Liverpool Range Wind Farm Noise Impact Assessment - Amendment

Report Number 640.10487-R02

3 February 2017

Liverpool Range Wind Farm

Figure 5 Background Noise Measurements and Noise Criteria Curve – Location D4-9

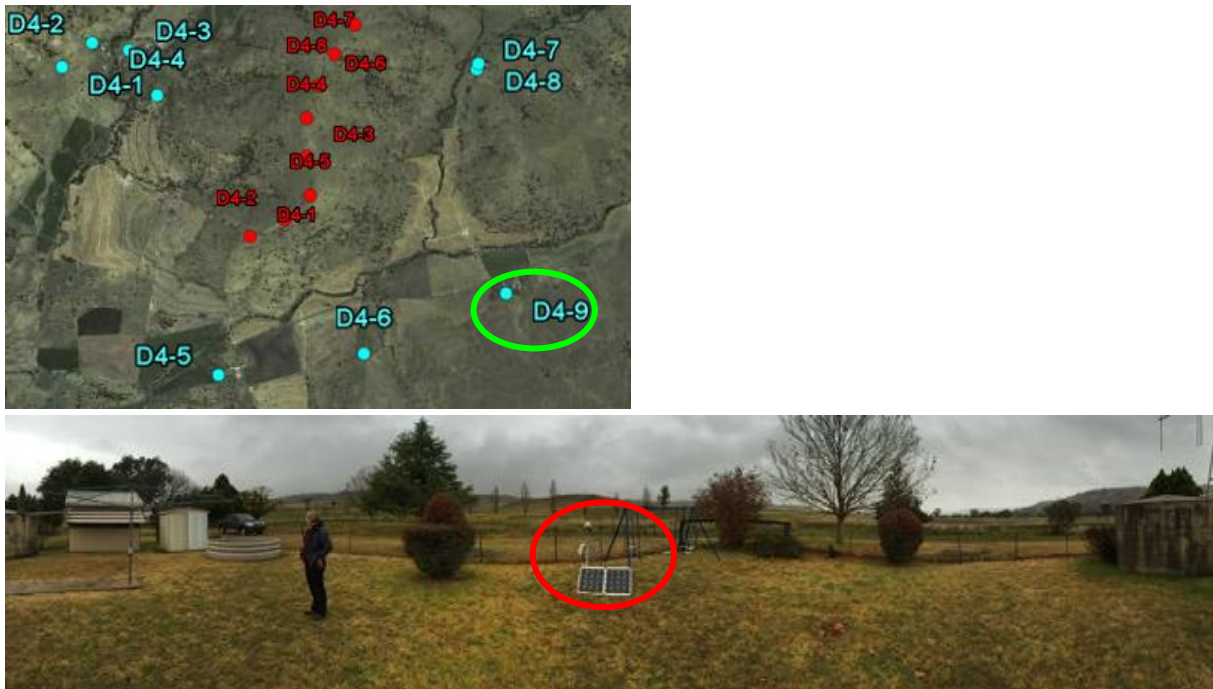
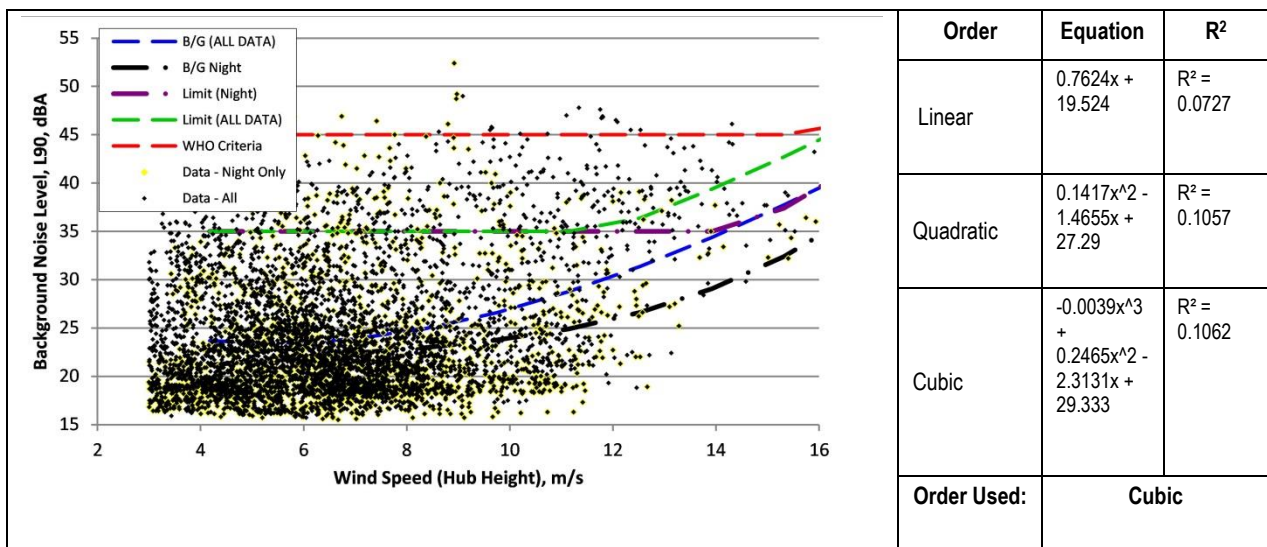
1. Undertake the additional monitoring referred to above or provide sufficient justification for not performing further background noise monitoring in Zone 3, as the number of valid data points used is significantly less than that recommended by the SA EPA guidelines, and the predicted impact at receiver D4-9 is greater than $L_{Aeq(10min)}$ 35 dBA and the criteria applied to other receiver zones;

Location D4-9 is located approximately 1.5 km to the east of location D4-6, between the ridges for turbines D4-1, D4-2 and D5-21 and D5-22. The nearest proposed turbine to this location is approximately 2.2 km away.

It is understood that the land-owner of receptor D4-9 will now have 'project involved' status and a corresponding noise agreement.

The updated monitoring data has generally resulted in lower background noise regression curves.

Figure 8 Receptors within 50m of roads

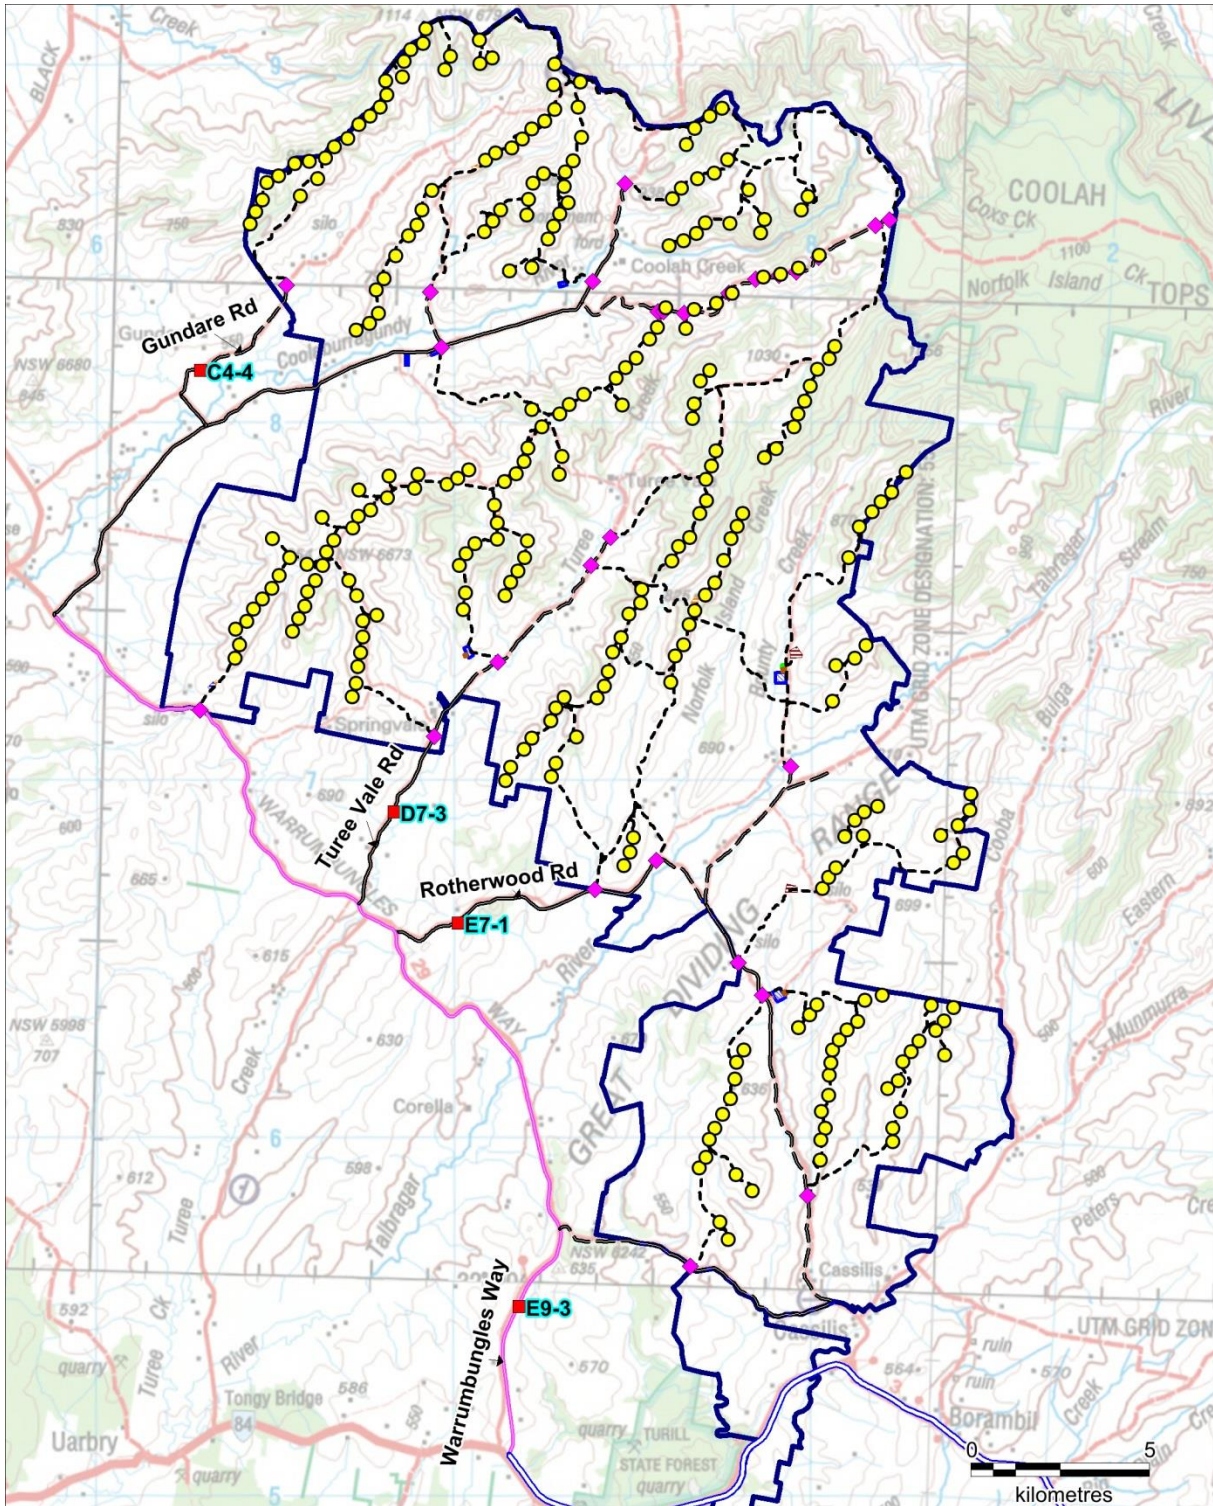
- There has been no quantitative assessment of noise impacts during construction due to increased traffic (up to 300 trips per day). It is stated that "the projected increase is expected to be greater than 2dB(A)" – however it is anticipated to meet the Road Noise Policy. Further justification is required demonstrating compliance with the RNP. Any uninvolved receptors closer than 50m from the public road on traffic key routes into the site should be identified – rather than state "most" receptors are at greater setback distances. Note that this will also be an issue for dust generation on unsealed access routes with residences at closer proximity to the road potentially impacted by dust generated from unsealed roads due to significant increase in traffic during construction. Mitigation measures to minimise dust will also need to be considered.

An analysis of receptors that are located within the 50 metre buffer has been completed by Epuron and are shown in **Table 3** and **Figure 8**.

House ID	Distance from road centerline
C4-4	40m
D7-3	24m
E7-1	38m
E9-3	30m

It is not anticipated that the above receptors are likely to be significantly impacted by road traffic noise as:

- The original assessment assumed worst case hour traffic volumes based on a conservative (high) estimate of the number of trips per day.
- The noise level at the closest receptor (D7-3) would only be approximately 3 dBA higher than that at the 50 metre setback.
